Project Number  
**UK22-17081**

# **SAKHALIN-2 PHASE 2 LENDERS' ENVIRONMENTAL CONSULTANT MONITORING REPORT SEPTEMBER 2017**

Project No. **UK22-17081**  
 Issue No. **03**  
 Date **23/03/2018**  
 Made by **Alan Fowler, Andy Snow, Peter Burston, Ekaterina Sladkova, Helen Yip**  
 Checked by **Helen Yip**  
 Approved by **Jon Hancox**

**Figure 5 - Soil and peat storage areas**

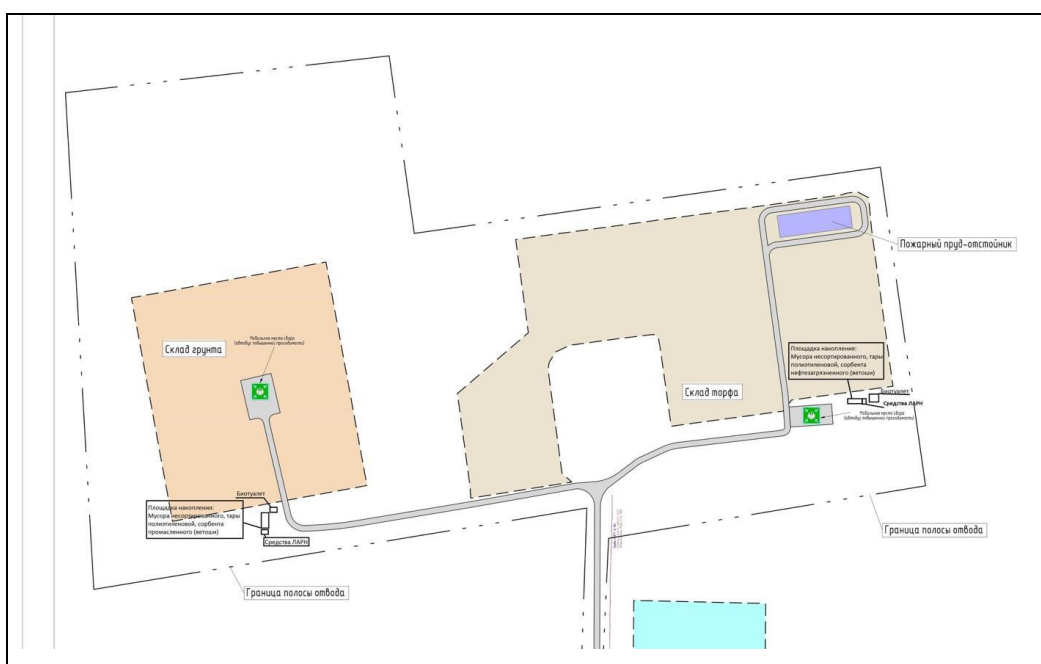
There are a number of potential concerns over the peat storage area. Firstly, it appears that the habitat losses caused by the footprint of the peat storage was not taken into account in the EHSIA. It is recommended that these losses taken into account by the Project BAP and assessed in terms of the IFC PS6 requirement of no net loss of natural habitats.

Ramboll Environ also has concerns over the peat storage design. Peat is formed when wet conditions create abiotic conditions, leading to incomplete decomposition of plant material (especially wetland plant species such as sphagnum moss). Because of the wet conditions and the lack of decomposition, it is naturally stored and gradually accumulates over long periods of time. If peat is allowed to dry out, it allows oxygen to enter the soil and decomposition to start, releasing CO<sub>2</sub> to the atmosphere. Therefore, if the aim of the peat storage is to preserve it for later use, it needs to be stored in wet conditions or in a way that ensures the air cannot come into contact with the soil and cause aerobic decomposition of the humus. The use of windrows and drainage is likely to cause peat drying and decomposition.

Long-term, further ongoing management is likely to be required to prevent colonisation of the area by woody species of plant and succession to scrub and woodland over the next 20-30 years, as well as the risk of fire during summer.

In terms of further recommendations, it is not understood whether the detailed storage methodology has been subject to state expertise review and formally agreed as part of the relevant permitting process. Therefore, Ramboll Environ requests further detail and documentation regarding the permitting of the peat storage methodology. Further detail is requested in respect of the planned monitoring programme for the peat storage area and water run-off. In addition, if monitoring results show that the peat is drying out, decomposing, washing out during high rainfall or snow melt, or causing deterioration in the nearby water course, Ramboll Environ would like to understand what rectifying measures can be taken, including the potential for redesign and reconfiguration within the conditions of the current permit.
